# TECHNICAL BULLETIN

DATE: 24 JULY 1972

## REWORK – 369H2048 DOOR LATCHING SYSTEM (AUTOLATCHING)

**Figure 1. Modification -Door Latching System (Autolatching), Pilot and Cargo Doors**

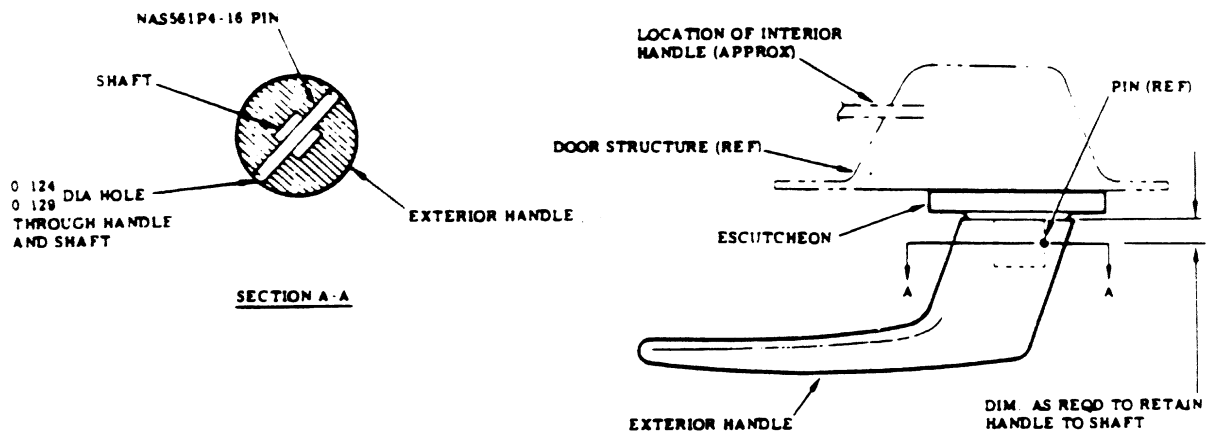
The information given in this Service Information Notice lists a procedure for modification of the subject door latching system. The rework is designed to provide added security of attachment of the exterior door handle to the latch shaft (spindle) for pilot and cargo doors.

- a. Using No. 30 drill bit, line drill through exterior door handle and door latch shaft (spindle) as shown in Figure 1.
- b. Reinstall latch shaft and exterior door handle, as required; install NAS561P4-16 spring pin through handle and shaft.
- c. Touch up finish with matching paint (Refer to applicable HMI Supplement).
